**METROLINK**

**MEMORANDUM**

**RE:** **Link Union Station (Link US) – North Loop and Number of Run-through Tracks**

<b>LINK UNION STATION ALTERNATIVE 1 UP TO 10 RUN-THROUGH TRACKS (SHARED TRACK ALIGNMENT)</b>	SCALE: 1"=500' DATE: 03-27-2018
--	--	--	------------------------------------

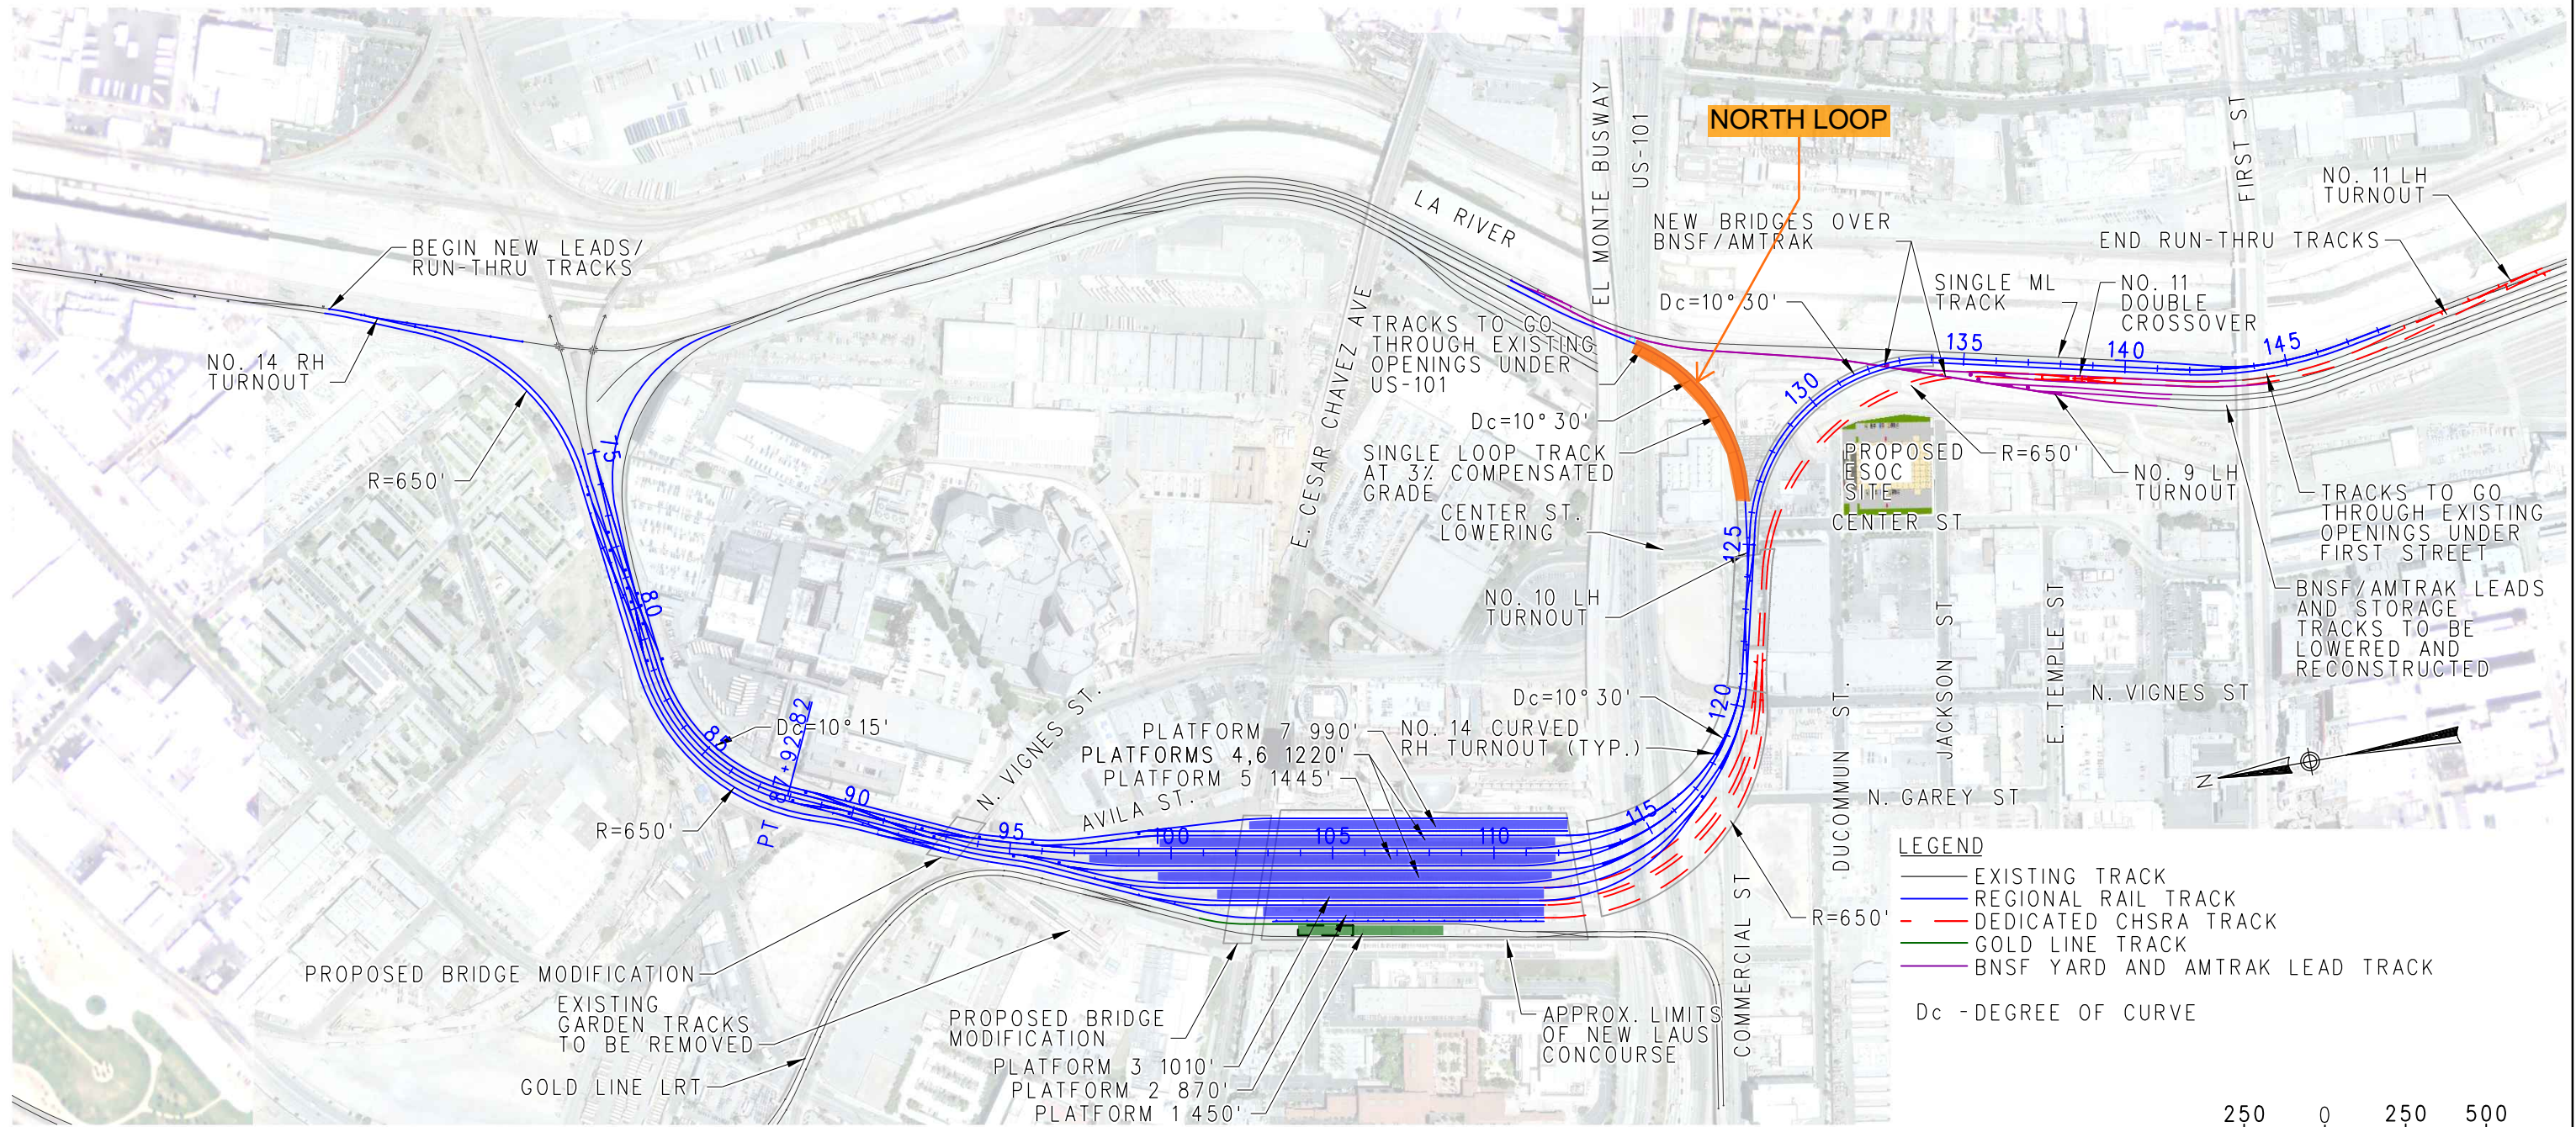
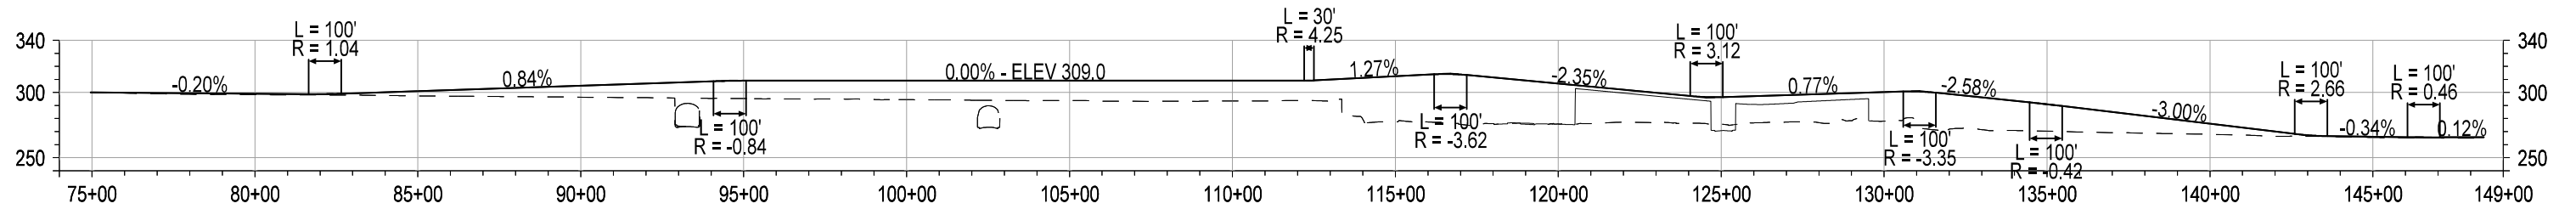
The elimination of the “North Loop” alignment of the Link US Project (noted in Exhibit A) to achieve a cost reduction and remain within the \$950M budget represents a substantial change to the functional design of the proposed facility. It would eliminate some combinations of run-through service (e.g. between the San Bernardino and Antelope Valley Lines) and reduce the added capacity of the expanded station, creating less new capacity to share between existing and prospective tenants. The elimination of the North Loop would also trigger the need to continue to make many turn-back moves and therefore negatively affects the capacity of this terminal.

A key benefit of the North Loop is to facilitate non-revenue moves between LAUS and the Central Maintenance Facility (CMF). Metrolink Lines that will benefit include Antelope Valley, Orange County, Riverside, San Bernardino, Ventura County and 91/Perris Valley Lines. Such moves are fundamentally critical to Metrolink’s current CMF-based equipment maintenance strategy. Our existing outlying maintenance facilities cannot support the type of maintenance activities that we currently undergo at the CMF, so the CMF remains as a critical location in our current operations plan.

As such, SCRRA conditionally agrees to move forward with the elimination of the North-Loop from the design under these conditions:

1. Further detailed operational analysis and network planning by SCRRA is required to determine the optimal future configuration of LAUS without the North Loop at two phases of operation – at the end of a first phase with just two run-through tracks (Phase A) and at the end of a second phase (Phase B) with use of two to four fewer platform tracks in the long-term operating configuration. This analysis and planning effort will be complete by Fall 2019.
2. Prior to beginning work on any stage of construction that takes any tracks or platforms out of service, Metro, in collaboration with SCRRA, shall prepare and test construction staging and operating plans that don’t degrade the existing performance and would in general sustain 94% on time performance (OTP) during

construction of both Phase A and Phase B. It is our understanding that the North Loop would have helped to mitigate construction impacts during Phase B construction.

3. Absent any future agreement or funding to transition to new operating strategies or complete the infrastructure needed for those new operating strategies, including but not limited to modifications and expansions to existing facilities (e.g. CMF, Eastern Maintenance Facility, Moorpark, Lancaster, and South Perris) and new facilities (e.g. Southside Turn Facility and Orange County Maintenance Facility), Metrolink shall operate at LAUS with the method of operation as it does today and with its planned level of service.

With regard to the present Metro-submitted 10% design, SCRRA agrees to move forward with the design of eight run-through tracks at LAUS under these conditions:

1. Ten tracks, six of which are run-through, are available for Metrolink and Amtrak, with compatible platform boarding heights in the long-term condition;
2. Should, in the future, CHSRA desire to convert any of those tracks and platforms to predominant CHSRA use, CHSRA shall not impact Metrolink operations, including protecting capacity for Metrolink's anticipated service growth. This could include shared platform use, technological and process improvements, and/or infrastructure investments (e.g. "Southside Turn Facility");
